STAFF REPORT

FILE NO.: DR-09-06 (Planning Directors Decision)

SUBJECT: Class I Design Review application to reconfigure an emergency driveway, build a new on-site circulation sidewalk, replace grass with synthetic groundcover on part of the outdoor play area, build a new storm water treatment facility, and other minor improvements at the Willamette Primary School at 1403 12th Street

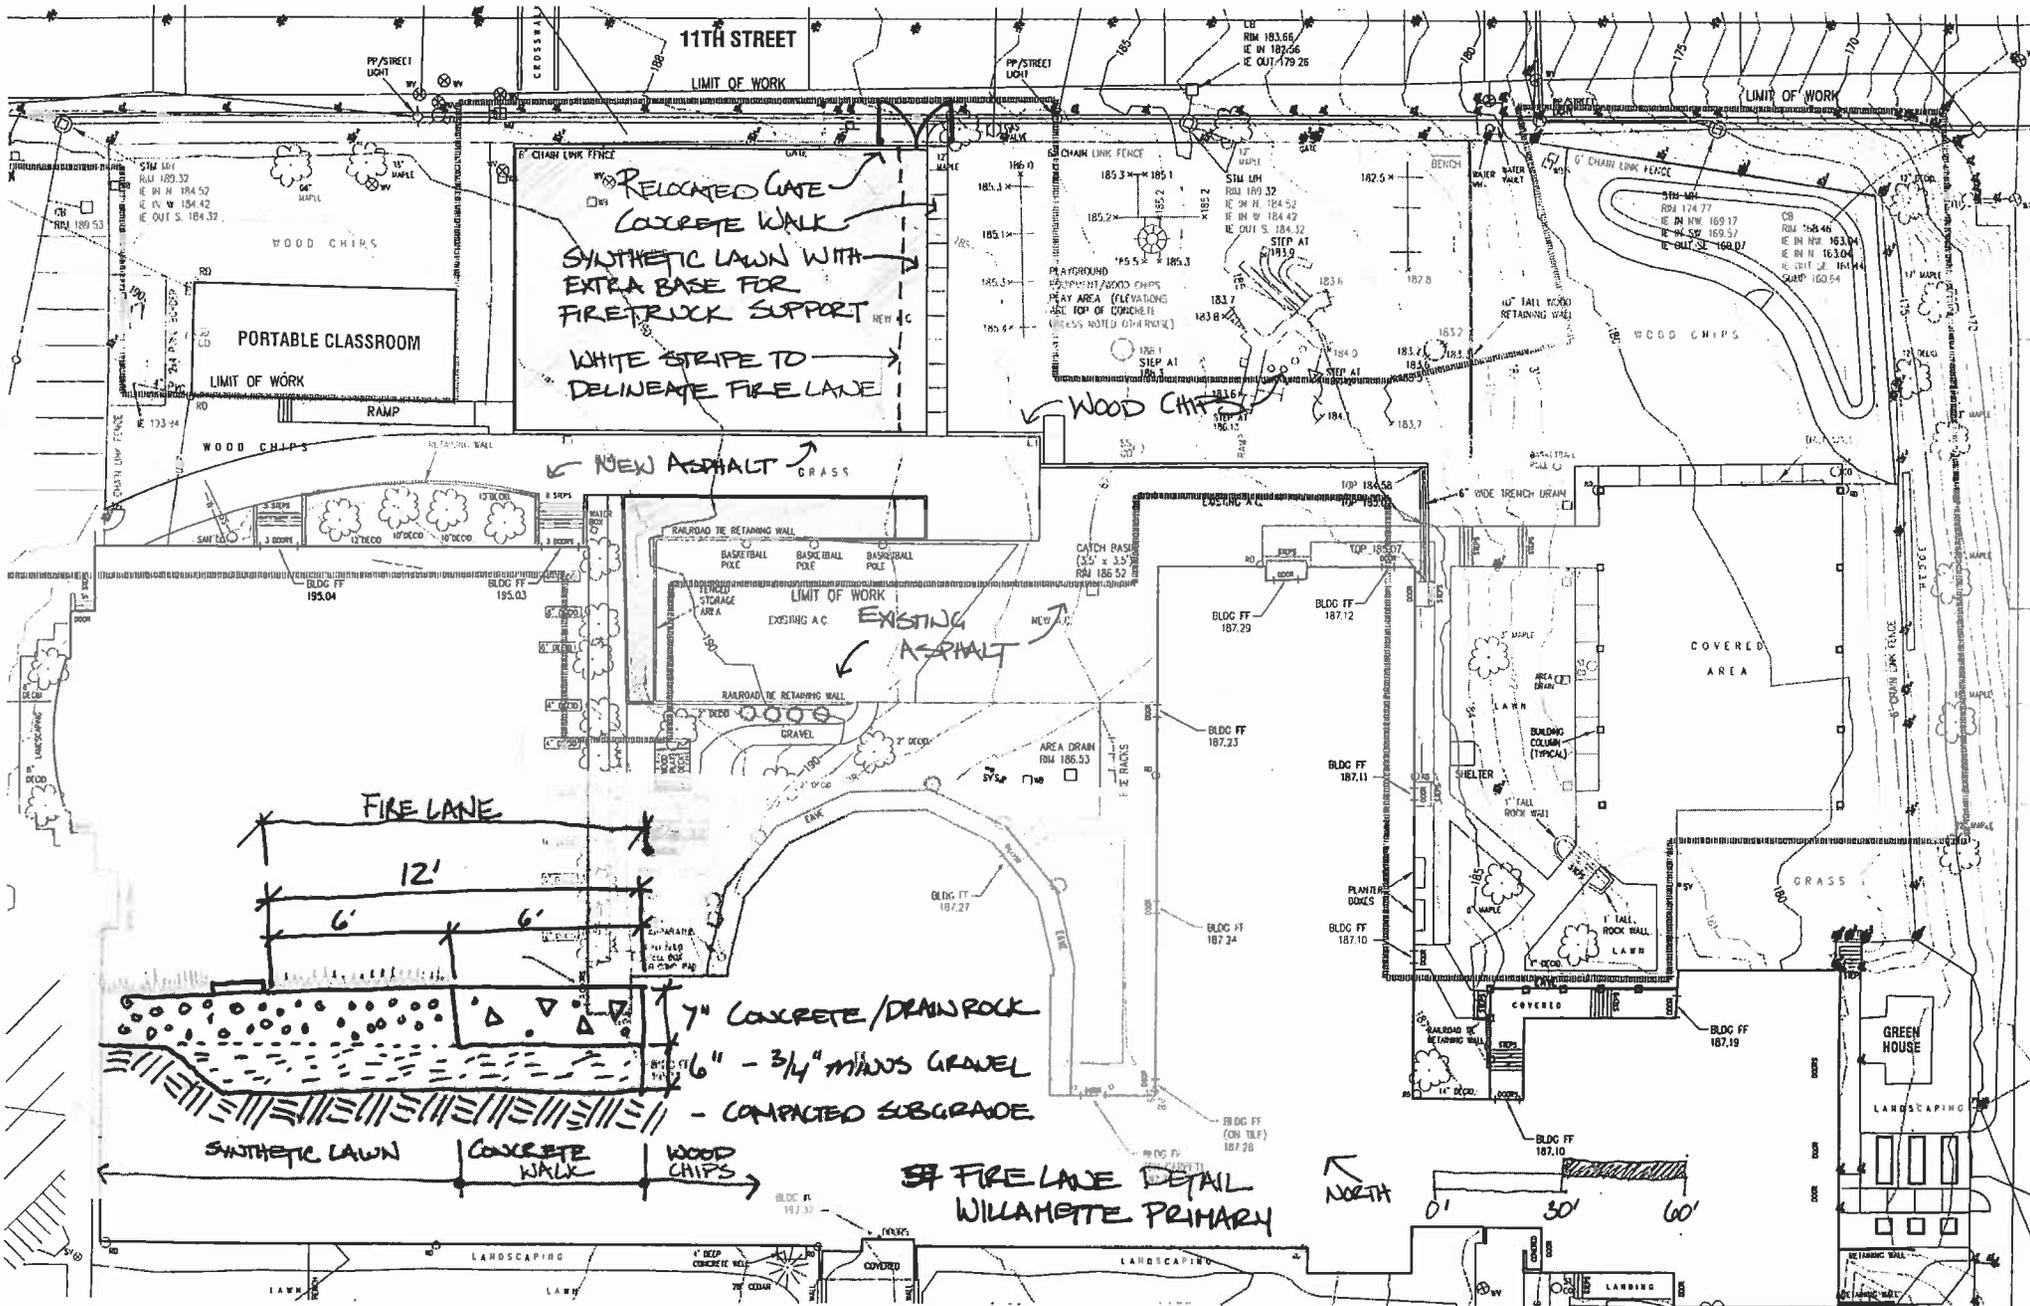
Thanks for the opportunity to review the proposed fire access to Willamette Primary School.

The Fire District endorses the proposal predicated on the following conditions of approval:

1. Gate opening is minimum 16' wide: 2 - 8' sections
2. Remove curbing in front of relocated gate, or, provide mountable curb design for approval
3. If gate will be locked, provide a Knox padlock to interlock in school district padlock, or, provide other Knox security device for fire department use – please contact me for assistance when ordering.
4. Provide “**No Parking**” signs on street in front of gate that is the entry to the emergency access.
5. Provide sign at/on gate to indicate that the marked “lane” is an approved emergency access road way – “**Approved Fire Lane**”.
6. Recommend: provide turning radius from 12' lane to new asphalt to avoid fire truck breaking off concrete while transitioning to new asphalt.
7. Fire Lane is engineered to hold 60,000 GVW.

9 16' WIDE FENCE GATE
SCALE: 1-1/2" = 1'-0"

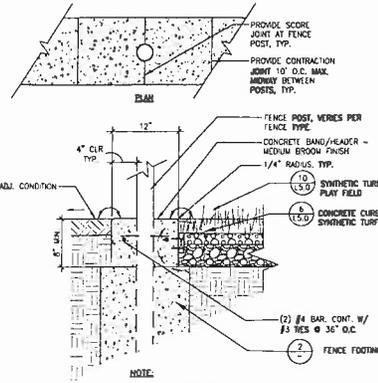
2. Applicant shall comply with all Fire District conditions of approval, which are as follows:
 - Gate opening is minimum 16' wide (two 8' sections).
 - Remove curbing in front of relocated gate, or provide mountable curb design for approval.
 - If gate will be locked, provide a Knox padlock to interlock in school district padlock, or, provide other Knox security device for fire department use- please contact Karen Mohling of TVFR for assistance when ordering.
 - Provide "No Parking" signs on street in front of gate that is the entry to the emergency access.
 - Provide sign at/on gate to indicate that the marked "lane" is an approved emergency access road way- "Approved Fire Lane".
 - Recommend: provide turning radius from 12' lane to new asphalt to avoid fire truck breaking off concrete while transitioning to new asphalt.
 - Fire lane shall be engineered to hold 60,000 GVW.
